Re: Bob's Burger
305 Eubank Blvd. NE
Traffic Circulation Layout
Architect's Stamp 05-17-2022 (D20-D049)

This letter is intended to address the comments submitted to my office on May 23rd, 2022 by Nilo Salgado. Each comment has been addressed independently in order. Adjustments have been made as defined below if necessary. Nilo was consulted on 07.18.2022. His responses are provided in RED. Ernest was consulted on site 08.19.2022. His responses are also provided in RED.

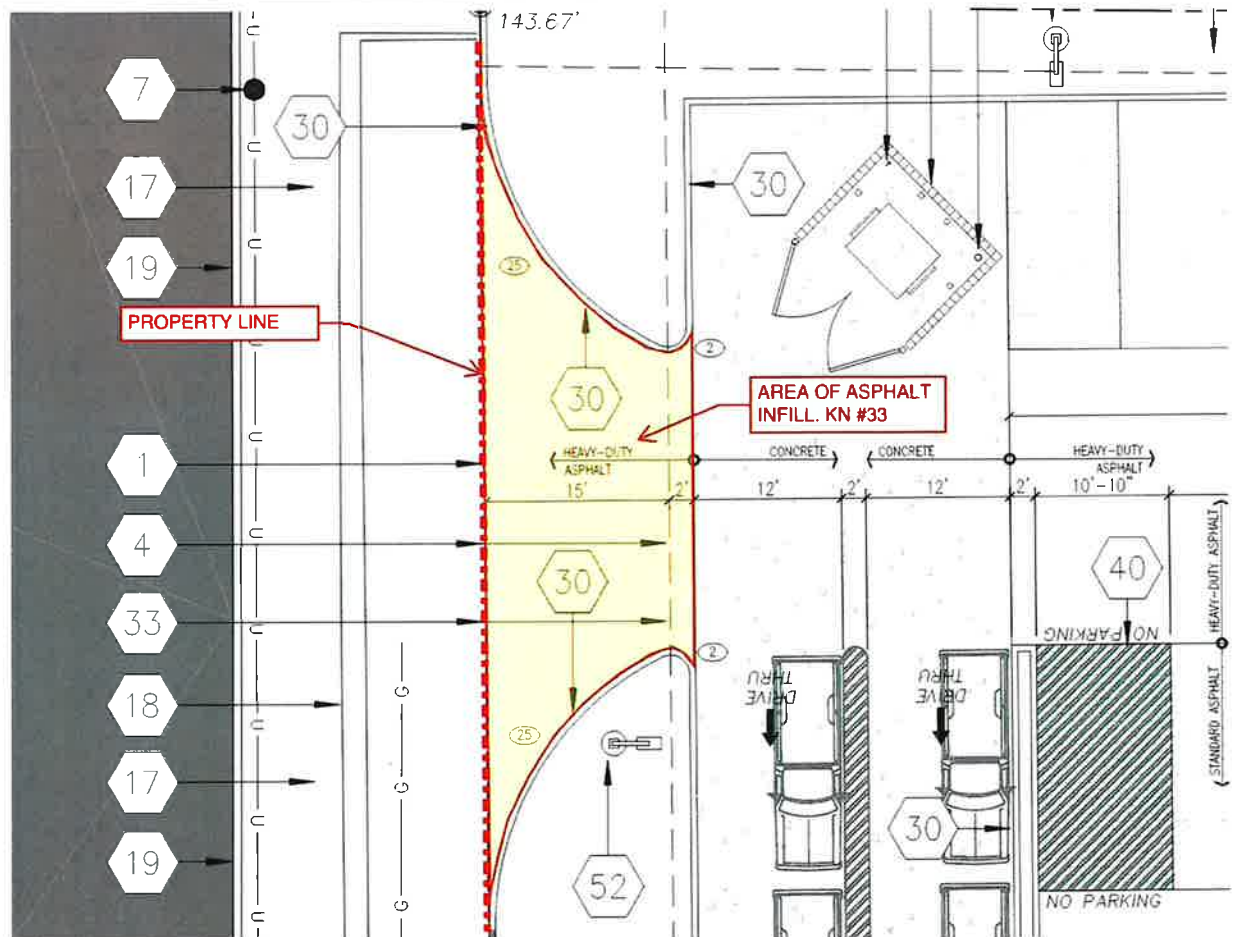
5. **Keyed Note 33: This will function appropriately on private property but not on Alley Way. Provide note to ensure this concern unless it is on Alley (Then a Work Order will be required)**

RESPONSE: As you can see keyed note 33 identifies an area on private property that will need to be filled in between the property line and the concrete drive pad of the drive-thru lane/dumpster enclosure. This area is currently filled with parking lot paving for the existing restaurant that will be demolished for new construction and left as blank dirt. We intend to fill in as part of the proposed drive aisle on the north end. See below.

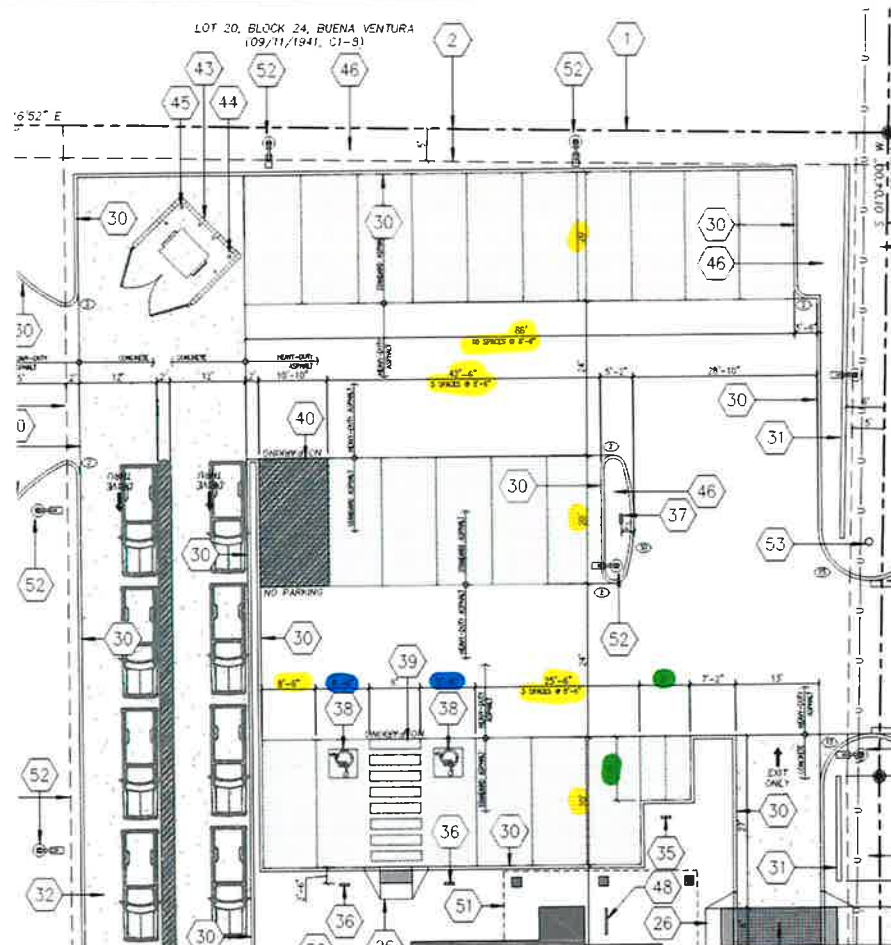
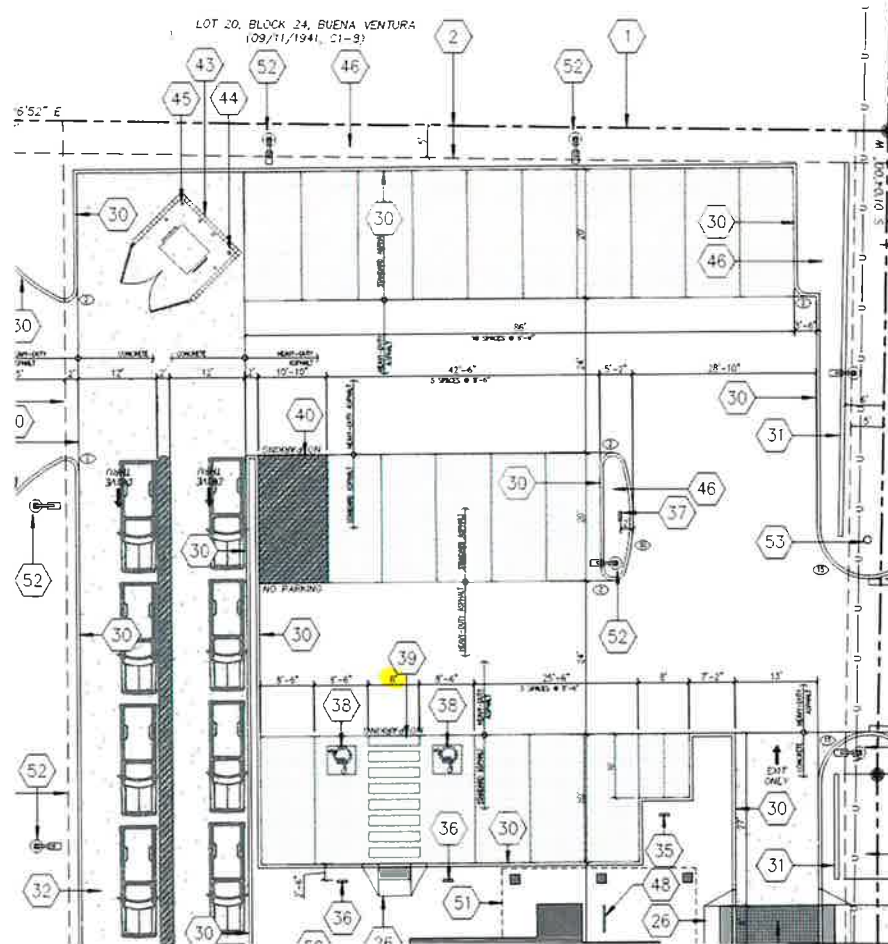
6. The minimum parking stall dimensions are (Some are not shown):

Type of parking	Min. Width	Min. Length	Min. Overhang
Standard	8.5'	18'	2'
Compact	7.5'	15'	1.5'
Motorcycle	4'	8'	N/A
ADA	8.5'	18'	2'

RESPONSE: All parking dimensions were identified. Standard spaces are designed better than code at 20' x 8.5'. We do not have any COMPACT spaces. Motorcycle spaces have been designed better than code at 10' x 4' each. ADA spaces have been designed better than code at 20' x 8.5'. I have highlighted all pertinent dimensions in the diagram below for your review:

Yellow = standard spaces
Blue = HC Accessible spaces
Green = Motorcycle spaces

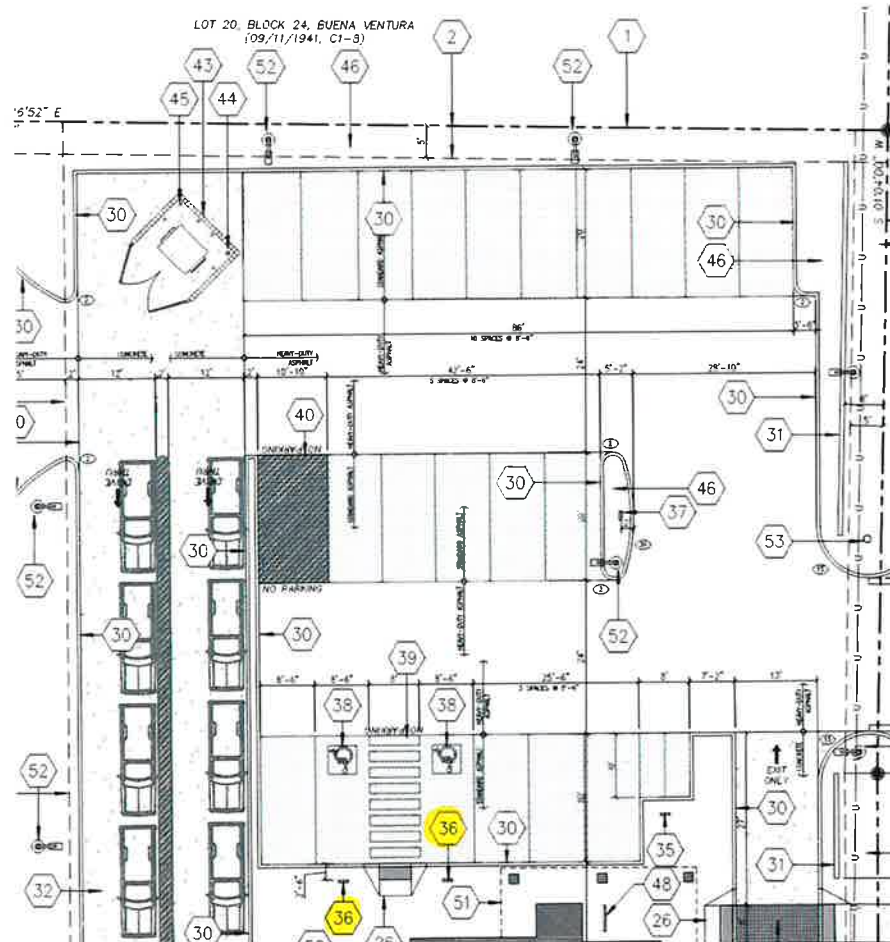
7. The ADA accessible spaces must include an access aisle. Van accessible aisles should be 8ft wide; all others should be 5ft wide.

RESPONSE: The van accessible aisle is provided at 8' wide. See attachment:

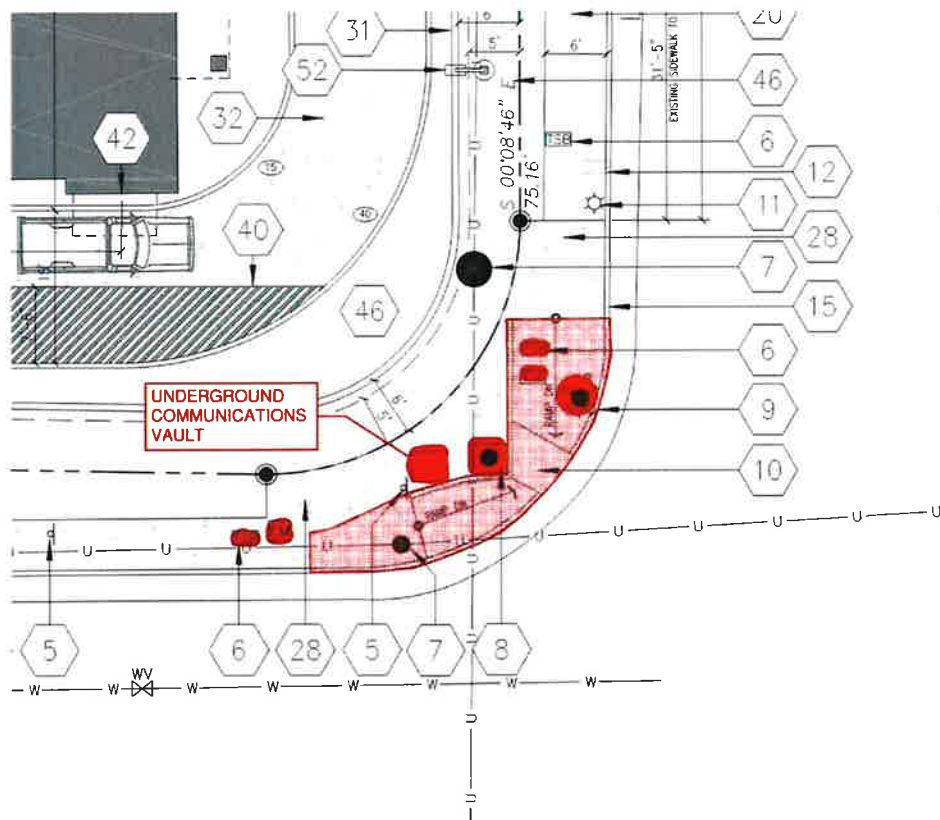
9. The ADA access aisles shall have the words “NO PARKING” in capital letters, each of which shall be at least one foot high and at least two inches wide, placed at the rear of the parking space so as to be close to where an adjacent vehicle’s rear tire would be placed. (66-1-4.1.B NMSA 1978)

RESPONSE: Keyed Note #39 has been modified to read “NEW HANDICAP ACCESS AISLE STRIPING. SEE DETAIL A4/AS-501.

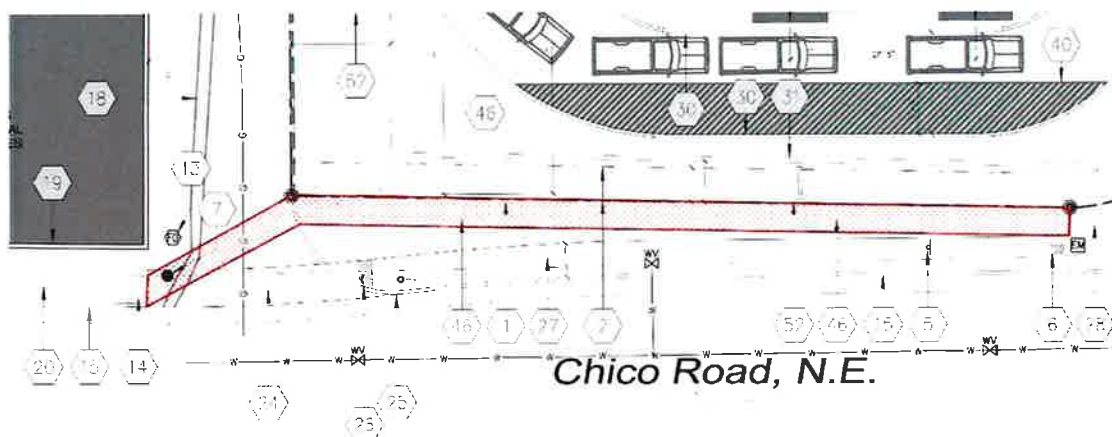
11. Chico drivepad:

- Provide details for all proposed infrastructure on plans.
- A special detail will be needed for drivepad transitioning from pad to curb returns (from a gutter pan to a 6' valley gutter).
- Locate proposed sidewalk segment to property line and not at back of curb as shown.
- You will need adjacent property owner permission to perform work on his frontage. Provide letter of permission.
- Call out COA std dwg 2430 for Keyed Note 27.

Mrs. Wolfenbarger requested a radiused entry to the Alley. The current condition more accurately reflects COA Detail 2428. At Mrs. Wolfenbarger request, we discussed changing the alley entry to COA Detail 2430 as mentioned above. Clear sight triangles were discussed in both directions from the alley (looking East and looking West). See Photograph below of existing conditions:

Due to the existing conditions, it is clear that the West side of the Alley cannot be modified as requested. If this was to be done, the existing PNM power pole and the existing in-ground communications vault would need to be relocated to accommodate a radiused entry. Also the private wall would need to be truncated and rebuilt to accommodate a clear site triangle.

As illustrated in the photo above and the submitted TCL, we propose to apply a new radiused entry on the East side of the Alley and the CLEAR SIGHT TRIANGLE is achievable.

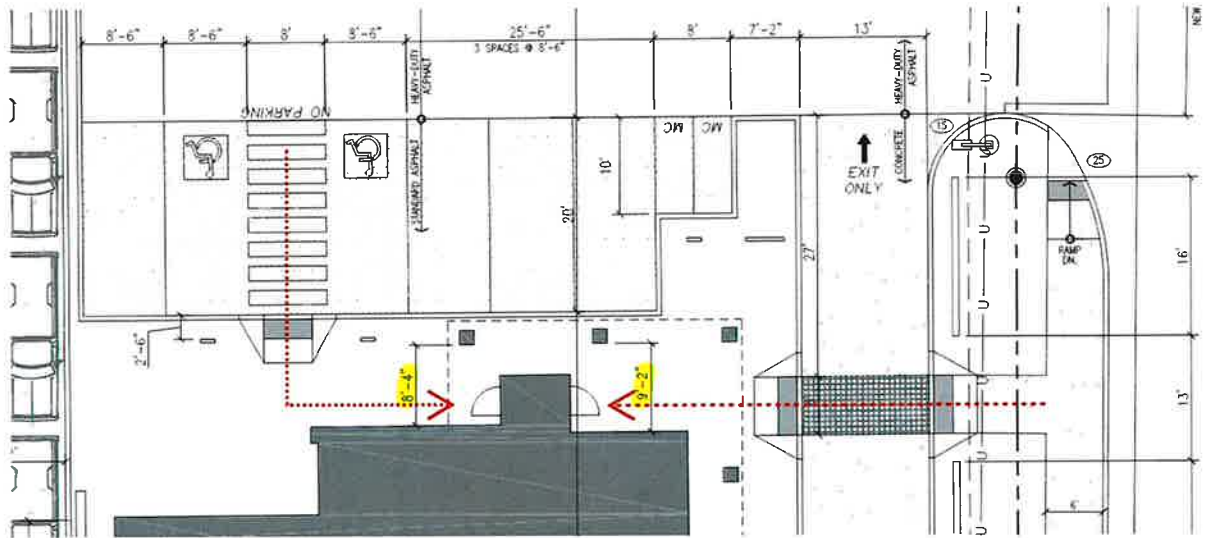
18. Per the DPM, a 6'ft. wide ADA accessible pedestrian pathway is required from the public sidewalk to the building entrances. Please clearly show this pathway and provide details.

19. Per the DPM, a 6'ft. wide ADA accessible pedestrian pathway is required from the ADA parking stall access aisles to the building entrances. Please clearly show this pathway and provide details.

RESPONSE: This criteria is met. See exhibit below.

RESPONSE: This criteria is met. See exhibit below. See keyed note #34.

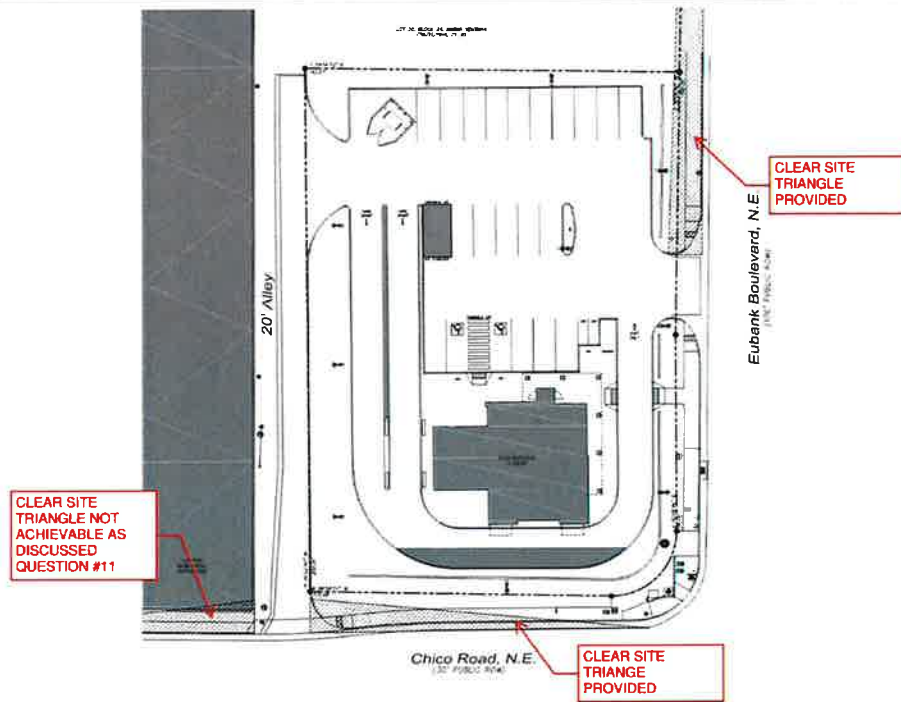
29. Please provide a site distance exhibit.

RESPONSE: As discussed above Question #11, the site triangle for the West side of the alley entrance is not obtainable with existing conditions. The East side of the alley entry is provided. The following criteria are required to determine the sight triangle:

Eubank Blvd: 50' ROW DIVIDED
40 MPH
Per COA Standards DI = 460'

Chico Road: 30' R.O.W. UNDIVIDED
25 MPH
Per COA standards Dr = 100'
Per COA standards DI = 130'properties
